**UNITED STATES
NUCLEAR REGULATORY COMMISSION
ADVISORY COMMITTEE ON REACTOR SAFEGUARDS
WASHINGTON, DC 20555 - 0001**

SUBJECT: CERTIFIED MINUTES OF THE MEETING OF THE FUKUSHIMA
SUBCOMMITTEE ON OCTOBER 19, 2016

ADVISORY COMMITTEE ON REACTOR SAFEGUARDS
MINUTES OF THE ACRS FUKUSHIMA SUBCOMMITTEE MEETING
ON OCTOBER 19, 2016

The purpose of the meeting was to discuss draft Regulatory Guides 1.226, 1.227 and 1.228 in support of the mitigation of beyond design basis events rulemaking. The meeting focused primarily on Regulatory Guide 1.226 and Revision 3 to NEI 12-06. Revision 3 includes guidance for mitigation strategy assessments for the new seismic hazard information that applies to all plants where the ground motion response spectrum is greater than twice the safe shutdown earthquake within 1 to 10 hertz frequency range. Recent changes to Regulatory Guides 1.227 and 1.228 were also discussed. The meeting transcripts are attached and contain an accurate description of the matters discussed during the meeting. The presentation slides and handouts used during the meeting are attached to these transcripts.

Path 5 Overview

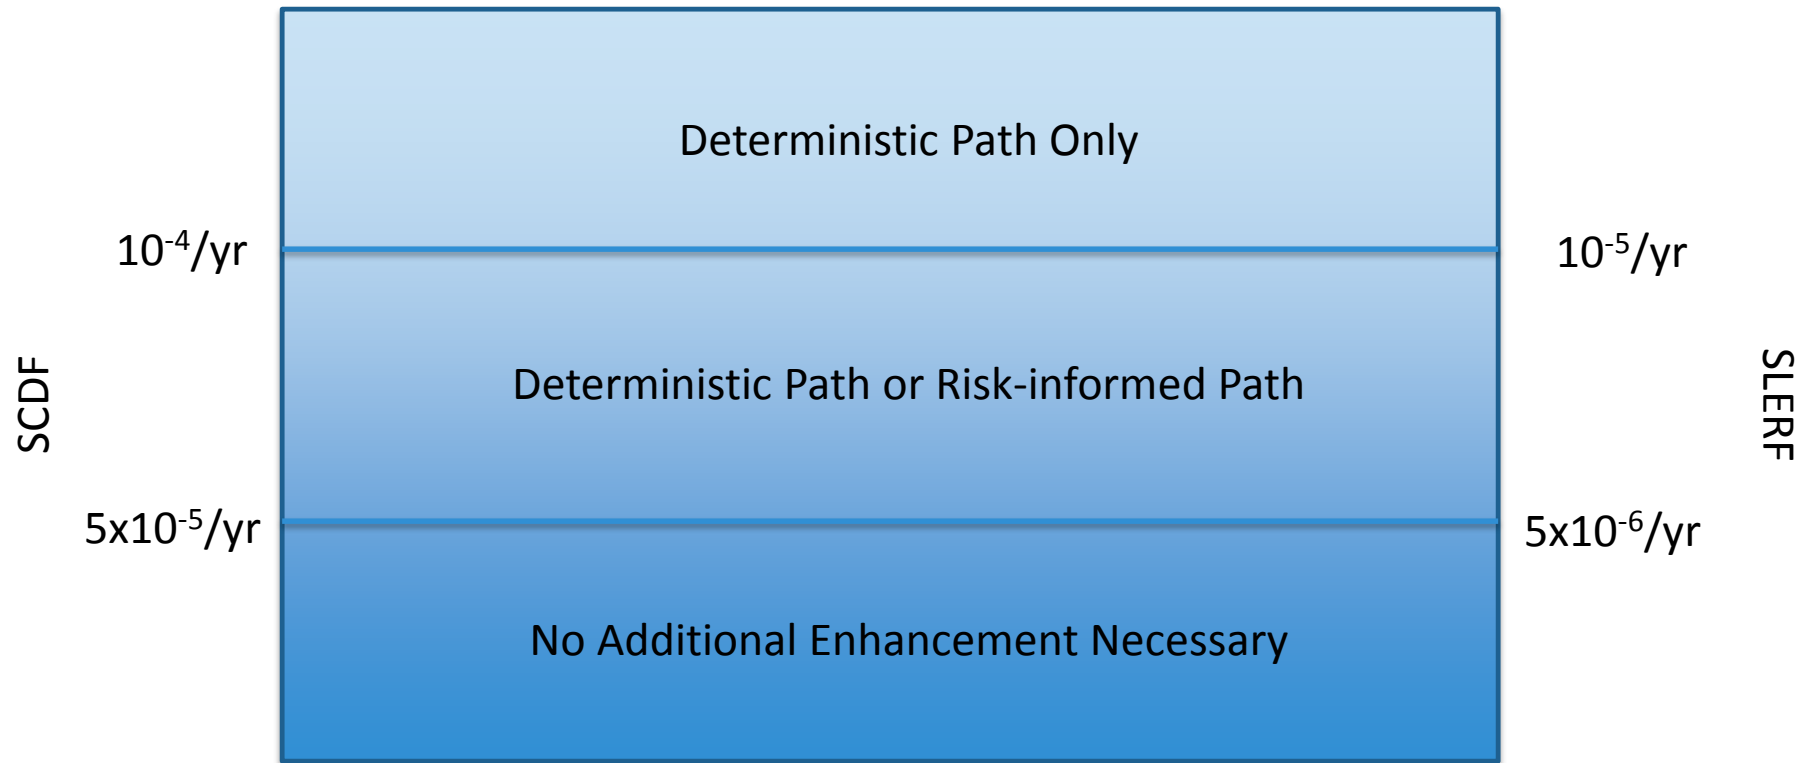
MEMBER RICCARDELLA: Yeah, this is Pete Riccardella. I have a question on Path 3. With all the other paths I see the connection to the mitigating strategies. But with Path 3, you rely on the top or the former PRA work to -- or IPEEE work to show that you have two safe shutdown paths.

CHAIRMAN STETKAR: Excuse me. According to this slide, I had several questions about the quality of the supporting IPEEE studies to support a Path 3 analysis. And we raised some of them in the previous Subcommittee meeting and we were told well, the staff had looked at them and were reasonably

I noted when you made the change from Rev 2 to Rev 3 of the guidance and it appears first in the Path 3 discussion, but I'm assuming it applies elsewhere. You -- Rev 2 of the guidance regarding the evaluation of spent fuel pool cooling said something to the effect that licensees following this path need to ensure the credited spent fuel pool cooling capability is maintained.

In Rev 3 you remove that little statement about spent fuel pool level instrumentation. So apparently, it doesn't need to be evaluated. Why is that?

MR. RICHARDS: So what is happening in Path 3 is that the plants have previously evaluated the seismic capability of the plant.

MR. RICHARDS: -- in California. So in Path 3, plants are crediting the previous seismic evaluation that they have done to ground motions that exceed their GMRS. And they have essentially demonstrated that they have adequate capacity to shut down the plant to -- and in truth, in truth, they will maintain AC power as well as open a heat sink.

MR. MAUER: So that's correct. In terms of -- there is two things going on here. One is based on the rulemaking progressing and some of the previous discussions that the Committee has had with the staff on that, there is a decoupling going on between the spent fuel pool level instrumentation order and Order 049.

So there is a decoupling going on there. In addition, if the strategies that are in place don't involve the level instrumentation to accomplish cooling, which there are other ways to provide makeup, you know, the level instrumentation doesn't necessarily do that. It wasn't -- it's not a part of the mitigating strategy assessment for this purpose.

Risk Regimes for Path 5*

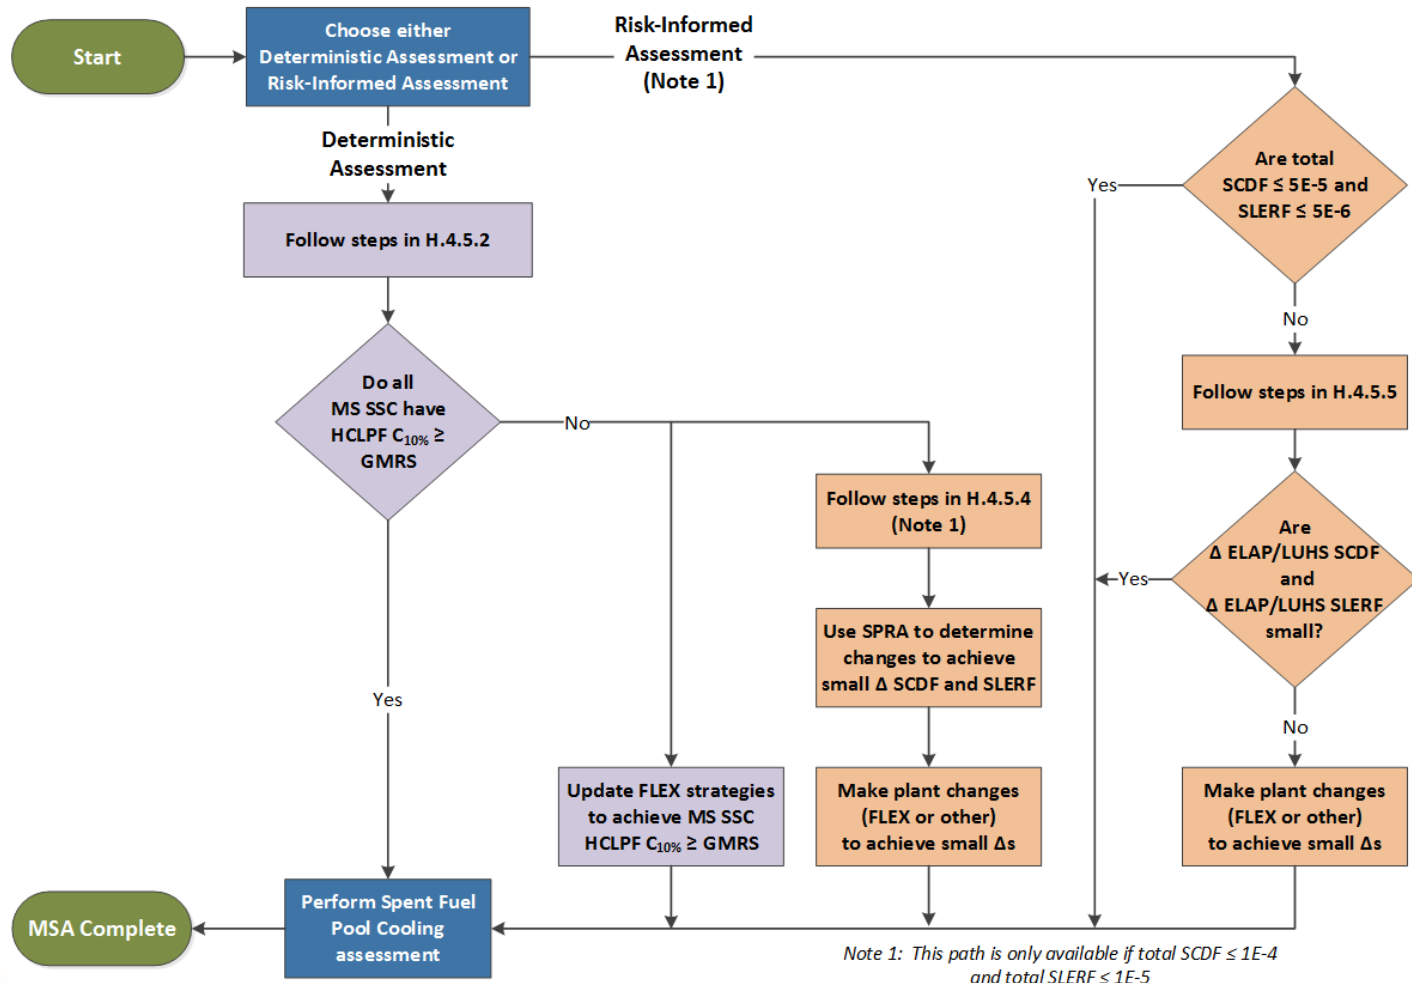
You might ask where did the 5 minus 6 come from and 5 minus 5. You might ask that. And I think the context of this is, look, we have already demonstrated the plants are safe for doing the seismic PRA. We want to focus our efforts on the plants that have the greatest opportunity for seismic benefits from mitigating strategies.

MEMBER BLEY: This just begs the question, I mean, the range over which you can do the risk-

was brought up, so in terms of the breakdown that you are describing, those plants that are affected by the LERF results versus those that are concerned with core damage, how does uncertainty affect that in terms of causing an evaluation to fall into the LERF category?

MR. TRUE: I'm not sure I know exactly how to answer that, other than as part of going through the seismic PRA in the peer review, there are requirements to look at the uncertainties, understand, and characterize those as part of what is being reported to the NRC as part of the standard and part of what we would always do and do in the seismic PRA.
